Work Order ID 92777

Item Name: 205 Skidtube bent detail

| DE APPR. | 10 | 205 SKIDTUBE ASSEMBLY | NTS |

| DRAWING NO. D2580 | TITLE 205 SKIDTUBE ASSEMBLY | REV. E | DART AEROSPACE LTD ENGINEERING ORDER | | D.E.O. NO. D2580-E-1 | SHEET NO. SHEET 1 OF 1 | SCALE NTS |

SECTION B-B, F-F, I-I
NOT TO SCALE

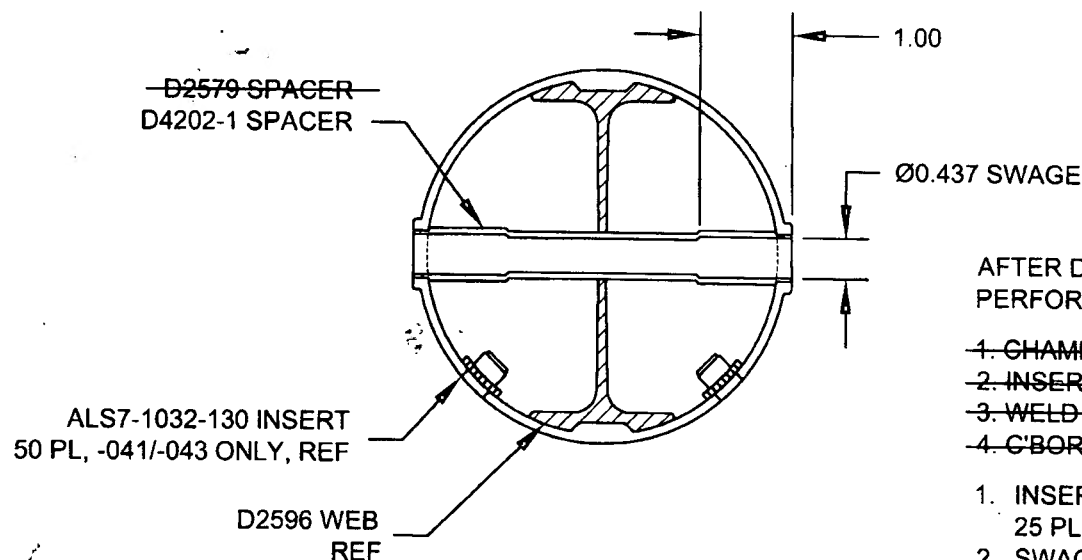
PURPOSE:

CHANGE ALL C'BORED WELDED CROSSBOLT SPACERS TO SWAGED SPACERS

SECTION B-B, SECTION F-F, & SECTION I-I ARE AMENDED AS FOLLOWS
FOR ALL HOLES THAT WERE ORIGINALLY C'BORED:

*** FOR -045 SKIDTUBE ONLY:**

WELD 4X D2579 SPACERS PER DWG
IN LOCATIONS MARKED "NO C'BORE".
REF SHEET 4 OF DWG.

AFTER DRILLING AND BENDING ASSEMBLY
PERFORM THE FOLLOWING FOR Ø0.508 HOLES ONLY:

1. CHAMFER HOLE 0.060 X 45°
2. INSERT D2579 SPACER (20 PLACES)
3. WELD INTO PLACE AND GRIND FLUSH
4. C'BORE D2579 SPACER TO Ø0.437 X 1.00 DEEP

1. INSERT D4202-1 SPACER, 20 PL (-041) OR 20 PL (-045) OR 25 PL (-047)
2. SWAGE TO Ø0.437 X 1.00 DEEP PER QSI 002
3. TRIM / GRIND FLUSH PER QSI 002
